Administrative Hearing: May 2, 2022

Sanctuary on the Green, PDP210018

Summary of Request

Sheet C3.04 16 of 30

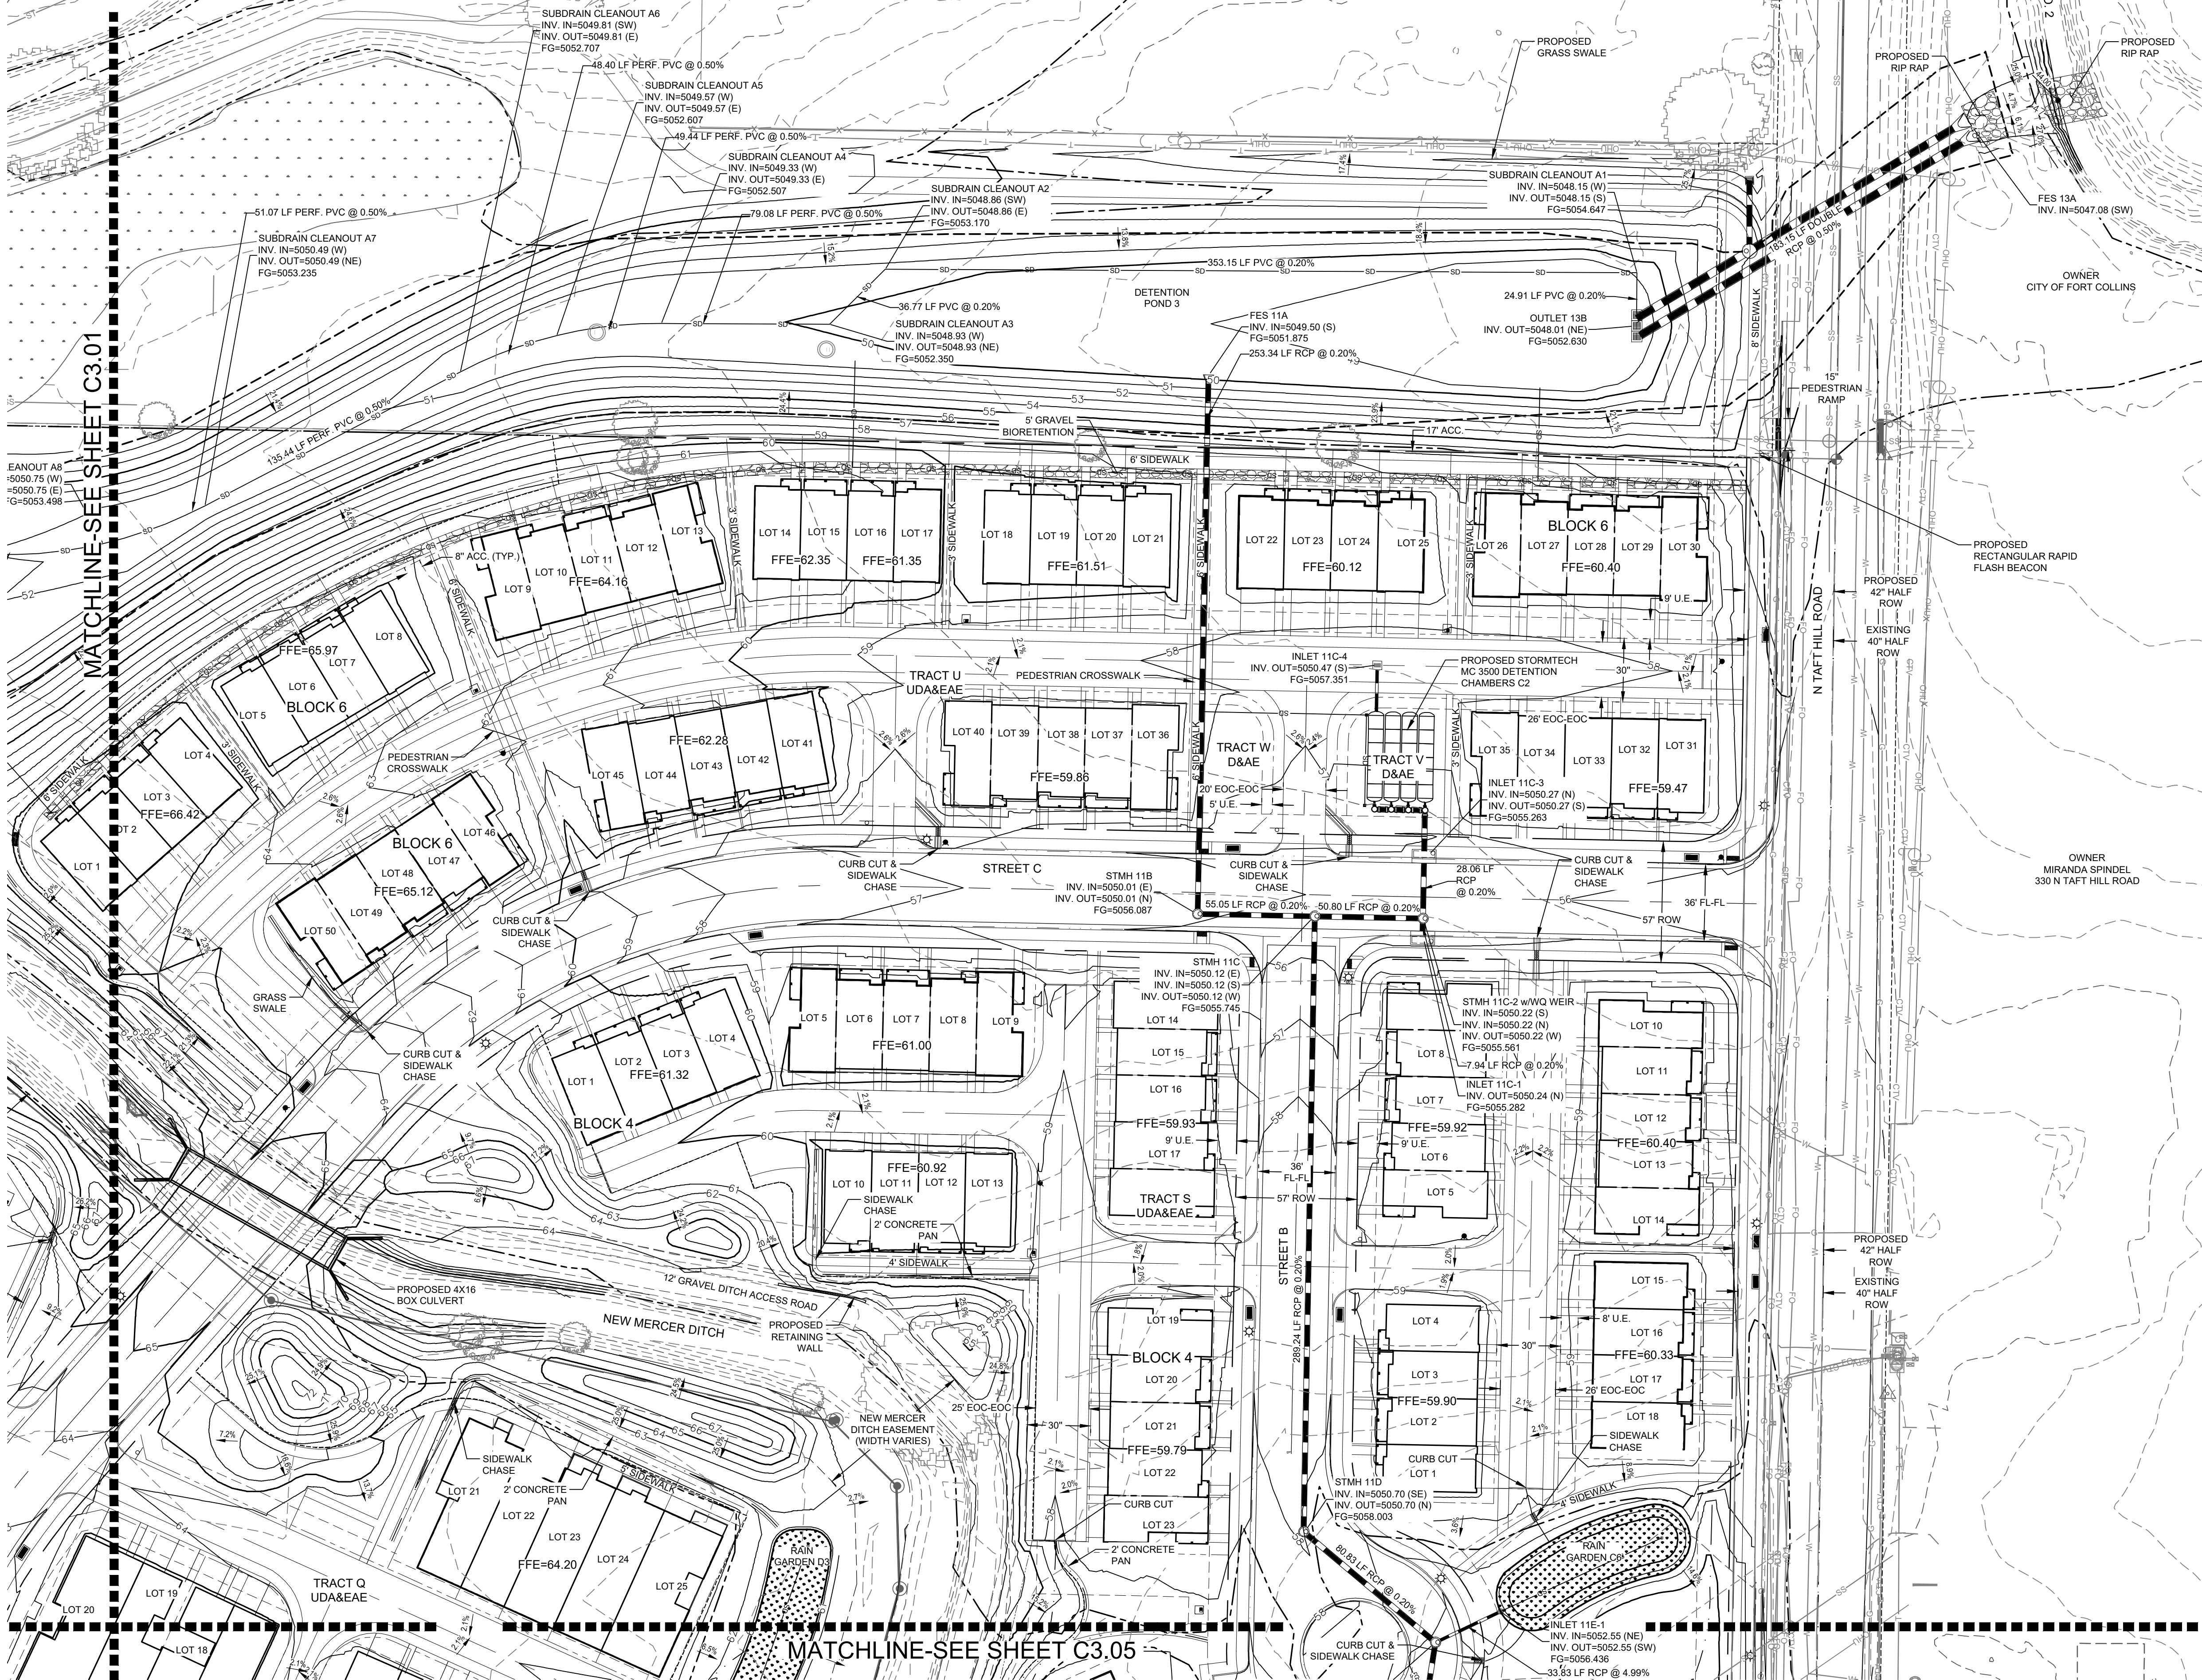
The grading and stormwater infrastructure within the NHBZ is not reflective of a naturalized aesthetic. Please vary the grading within the NHBZ so that it does not look engineered. This is particularly the case on sheet C3.04.
